MALLORY SONALERT PRODUCTS, INC.

Number: 22004

PRODUCT CHANGE NOTIFICATION

P/N: PB-12N23P-05Q

Sales Outline Drawing

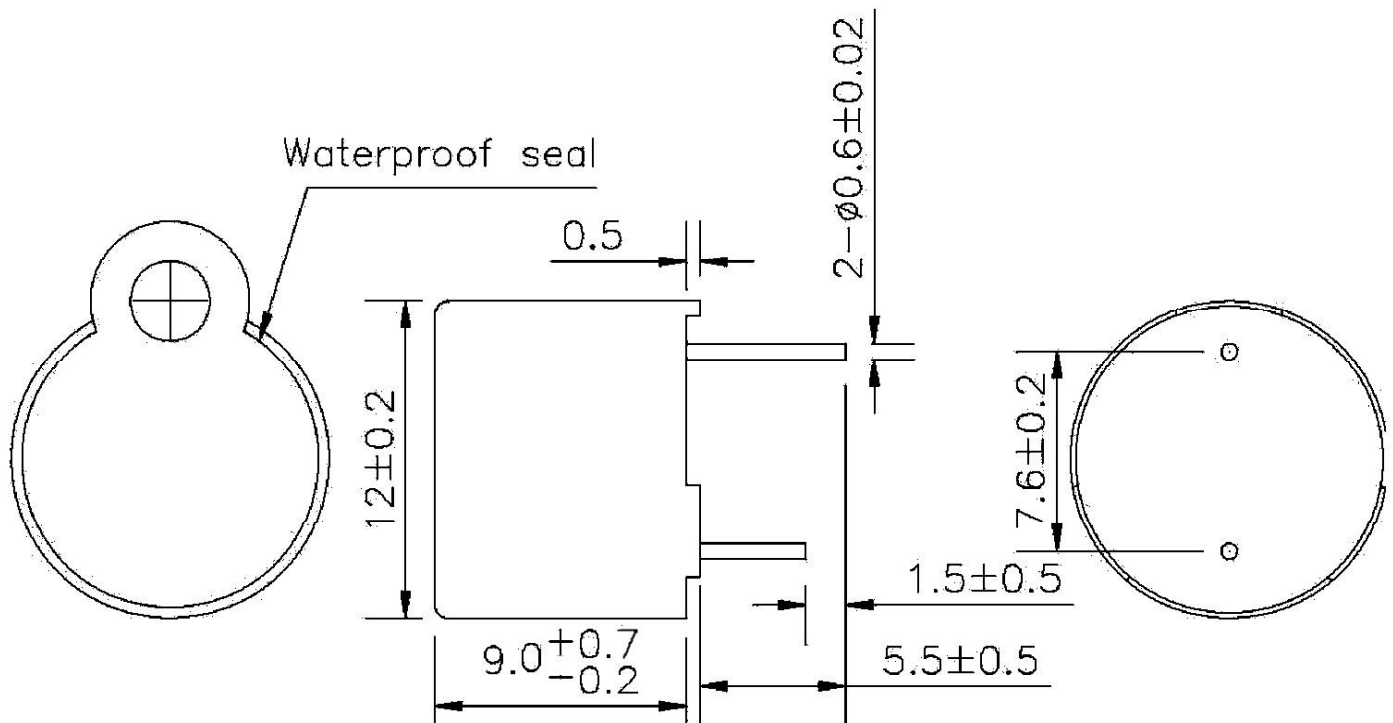
The height of the alarm will change to 9.0mm +0.7mm / -0.2mm

Due to supply issues, the factory is getting materials from dual sources. With this change, there will be a slight size change to the above part
